**APPLICATION FOR PERMISSION
UNDER SECTION 16 OF
THE TOWN PLANNING ORDINANCE
(CAP. 131)**

S.16 Application – Proposed Temporary Warehouse (Storage of Spare Parts and Recyclable Materials (Metal)) for 3 Years at Various Lots and Adjoining Government Land in D.D. 80, Lin Ma Hang Road, Ta Kwu Ling, New Territories

Appendix 3 – Response to PlanD Comments (STN/DPO and Follow-up Queries)

Appendix 4 – Response to Consolidated Departmental Comments

Layout Plan

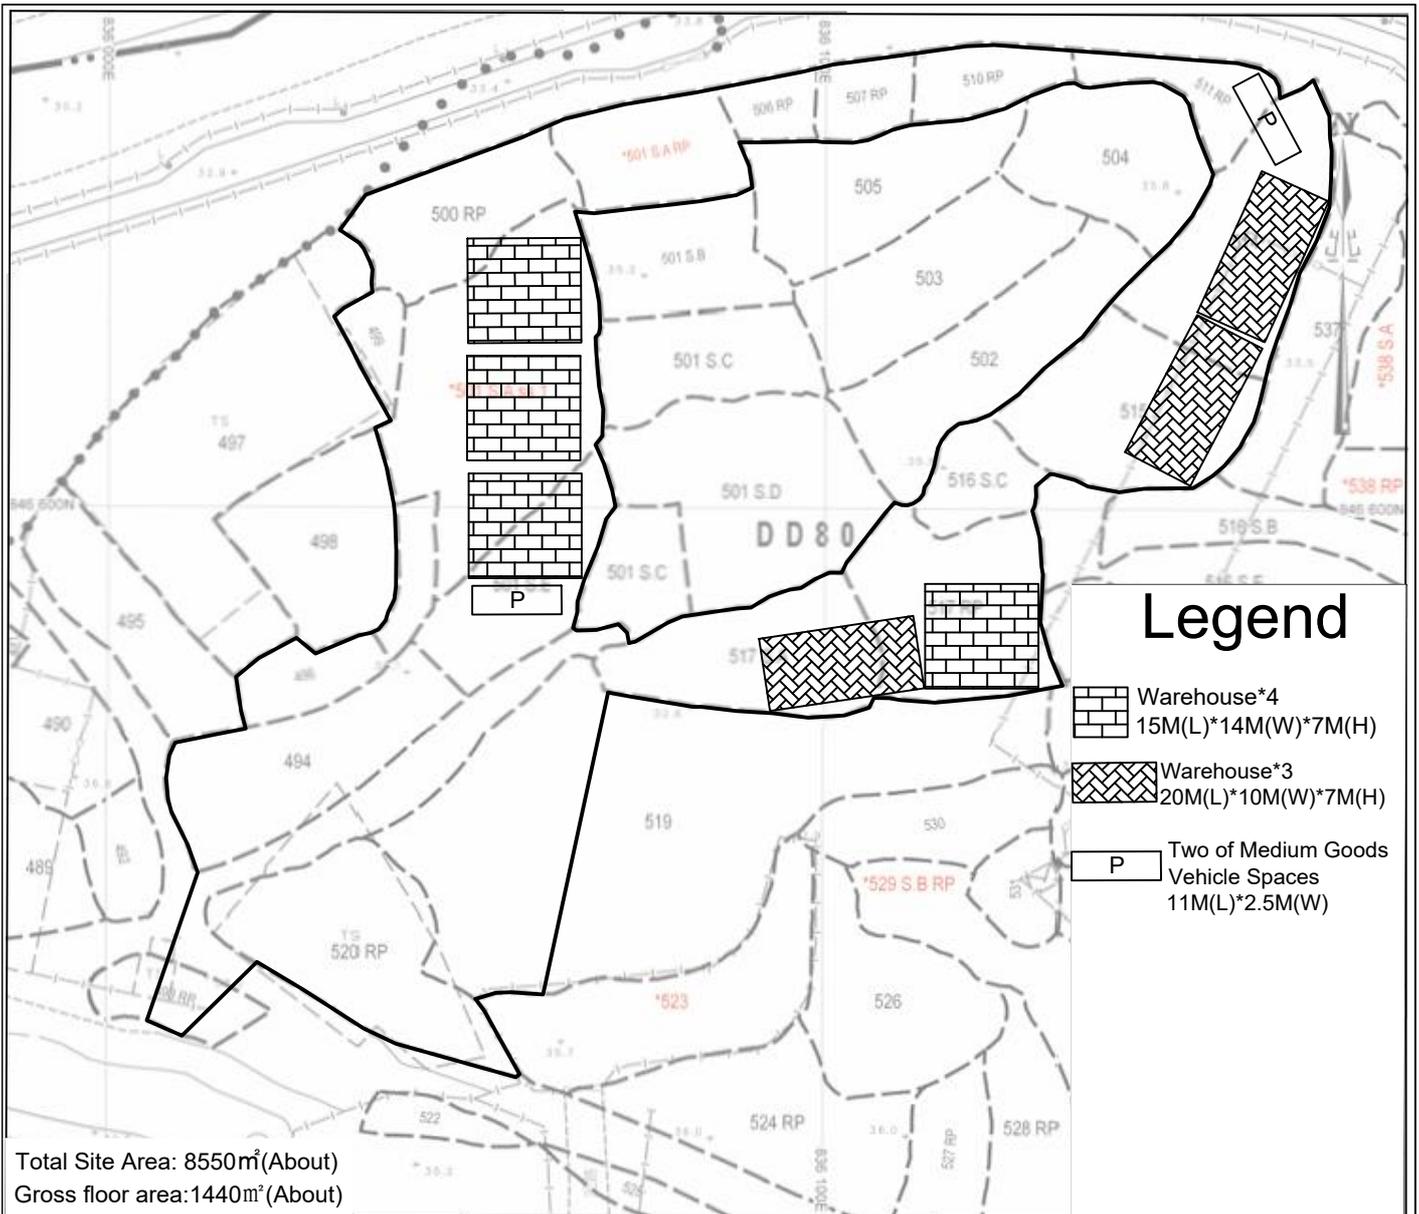
Comment 5 – Layout plans not to scale; indication of loading/unloading spaces and access

STN/DPO noted that the layout plans were “not to scale” and requested scaled plans showing the two loading/unloading spaces and the site access.

- a scaled layout plan (1:1000) with north point;
- clear delineation of the site boundary, internal circulation areas, frontage greening strips and landscape buffers;
- clear indication of the two medium goods vehicle (MGV) loading/unloading bays;
- the alignment of the vehicular access connecting Lin Ma Hang Road to the site; and
- the reserved access corridor to Lots 501 S.B–S.D and 502–505 as noted above.

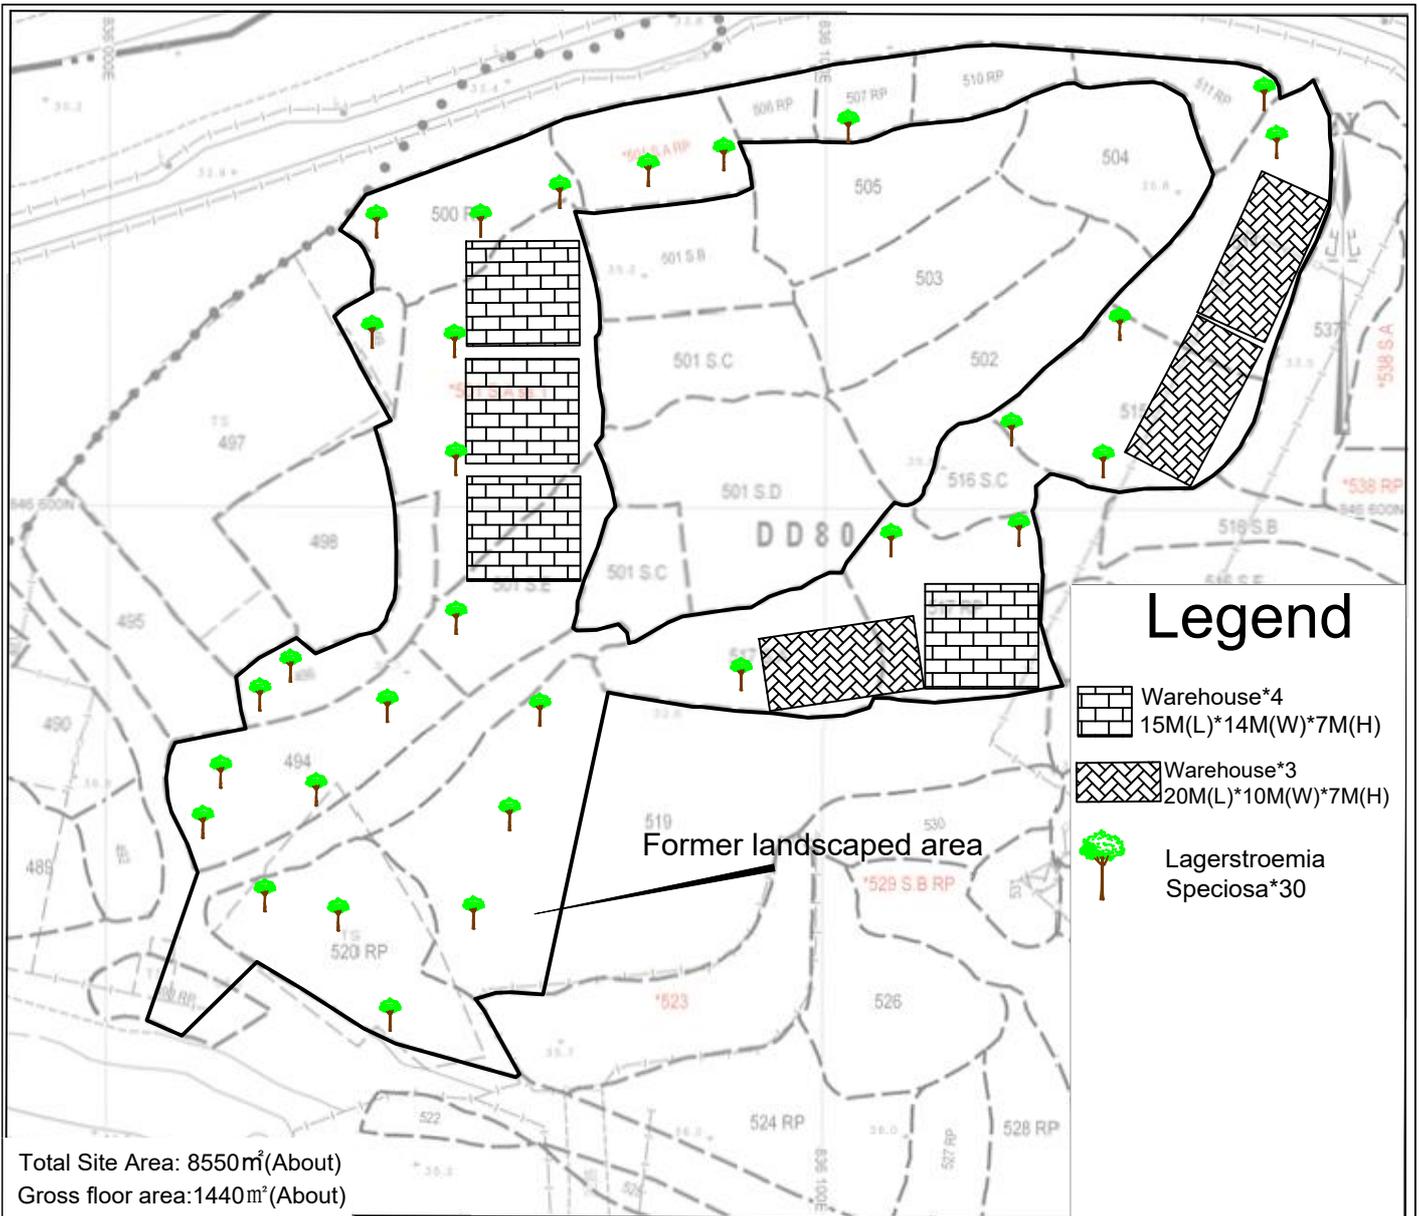
Comment

- retain existing trees as far as practicable;
- implement the **Landscape Plan** (over 30 new trees and planting belts); and
- seek separate approvals for any pruning, transplanting or felling from relevant departments before commencement of works.

Swpet Path Plan

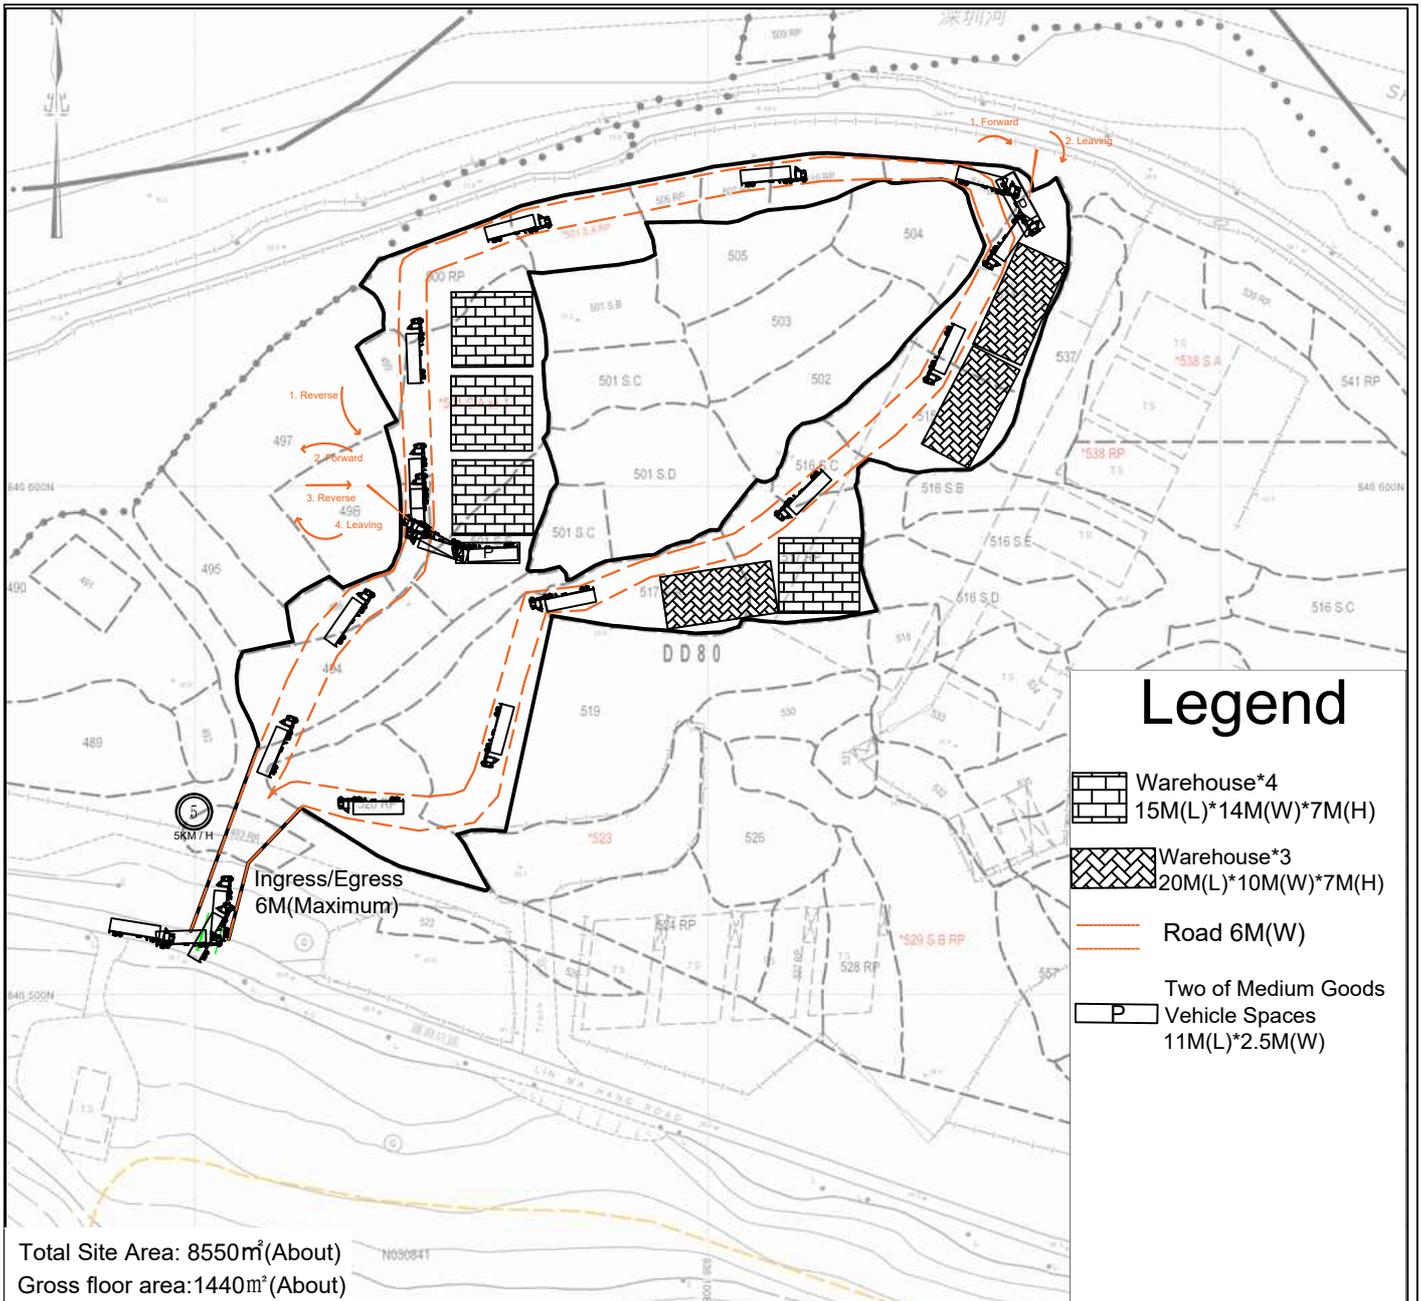
Comment 2 – Satisfactory manoeuvring of goods vehicles and swept-path analysis

The Applicant will prepare updated **swept-path diagrams** using appropriate design vehicles (e.g. medium goods vehicles) to show:

Title: Drainage Proposal - LAYOUT D01

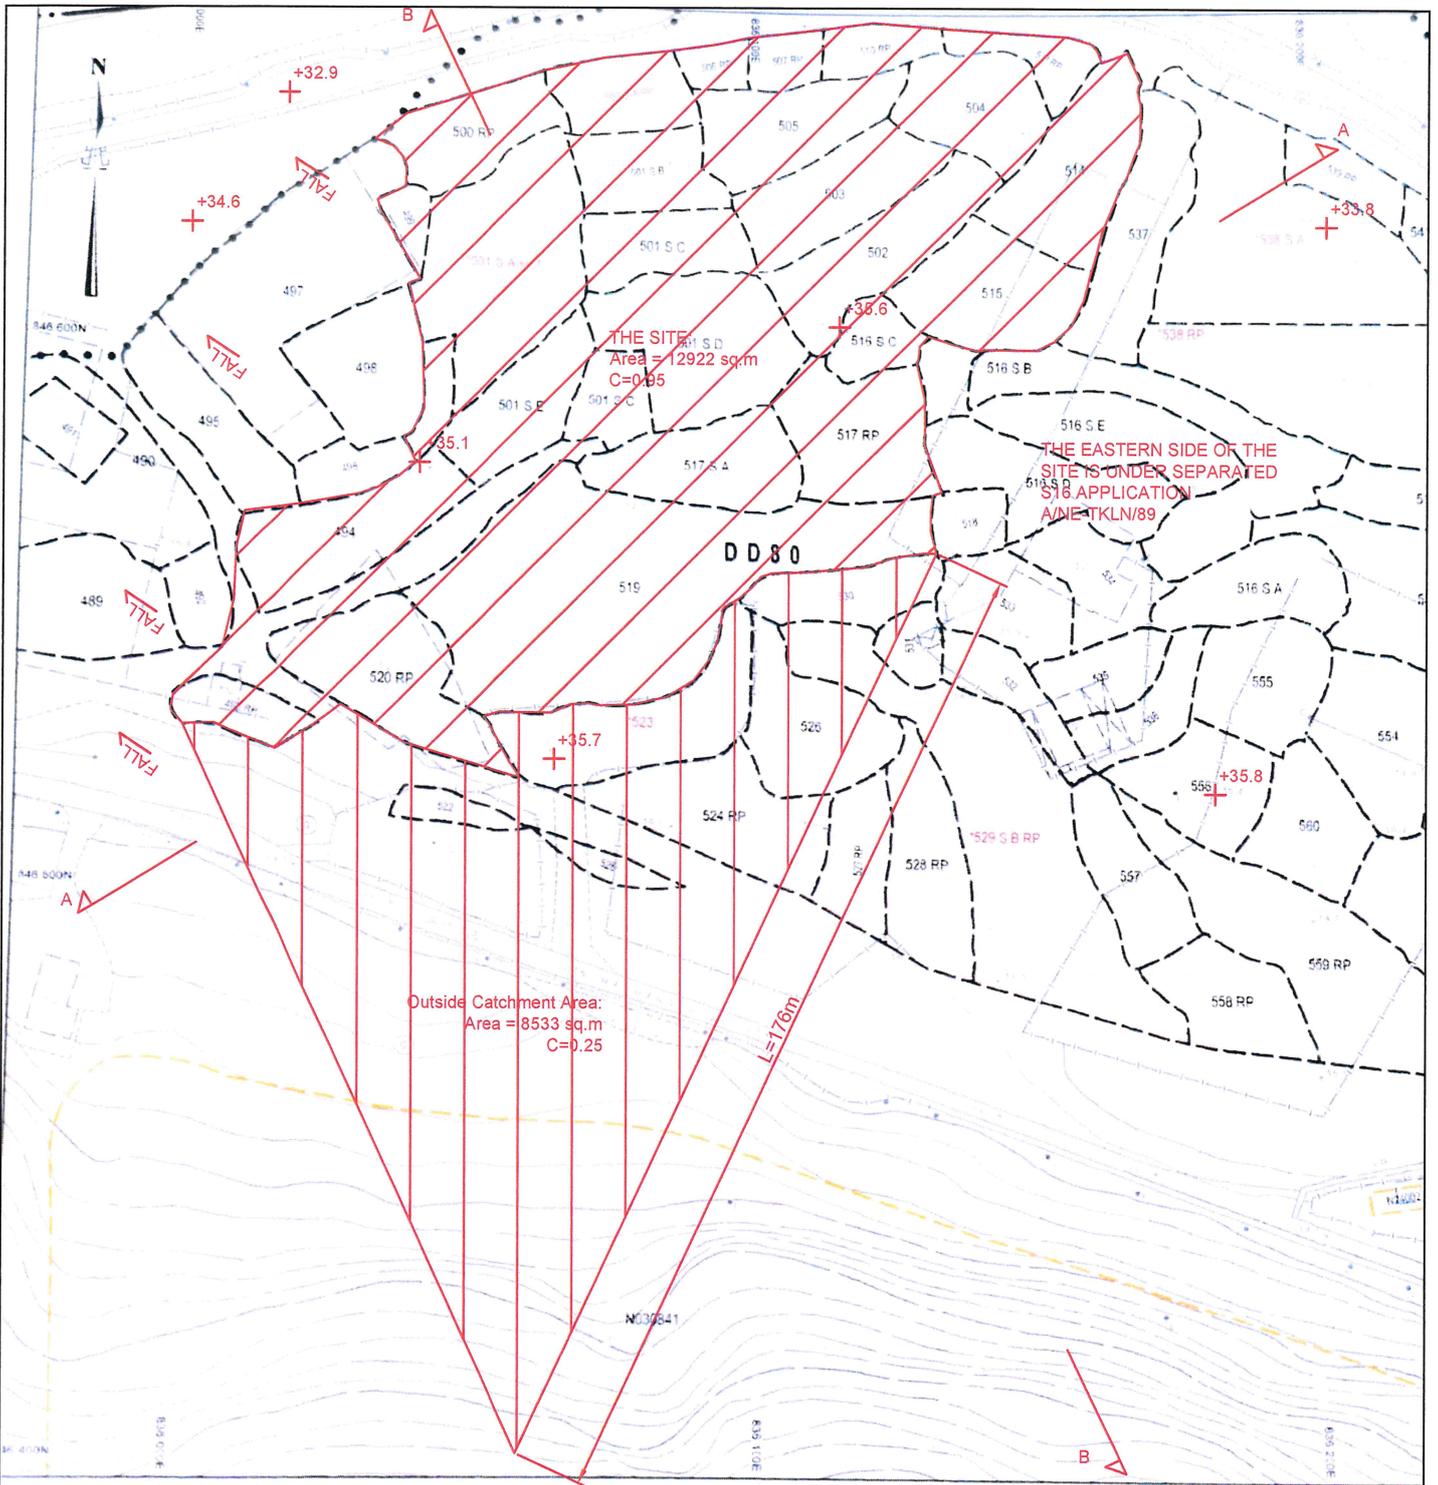
Comment

- a condition requiring submission and implementation of a drainage proposal;
- proper maintenance and rectification of the drainage system during the planning approval period; and
- all drainage works (within or outside the site) being at the Applicant's own expense.
